**WARRANTY
BULLETIN**

Wb98-31A

DATE : October 1998	SECTION : 05
EXPIRATION : October 1999	
SUBJECT : AUXILLIARY A/C REFRIGERANT PIPE PROTECTION

FIGURE 2 : CONDENSER

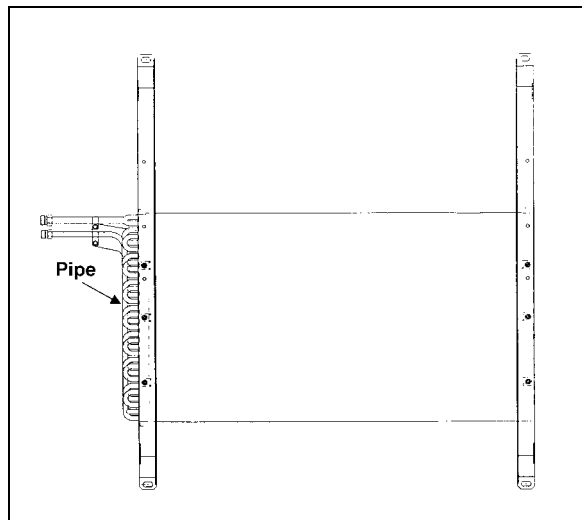
The refrigerant pipe may wear by rubbing against welds on the condenser. Installing a protective sheath will prevent this situation.

1. Open the radiator door (Fig. 1);
2. Find the refrigerant pipe to the left of the condenser (Fig. 2);
3. Cut about 13-3/4" (350 mm) of sheath;

4. Install the sheath on the length of the pipe at risk of being in contact with the condenser;
5. Close the radiator door.
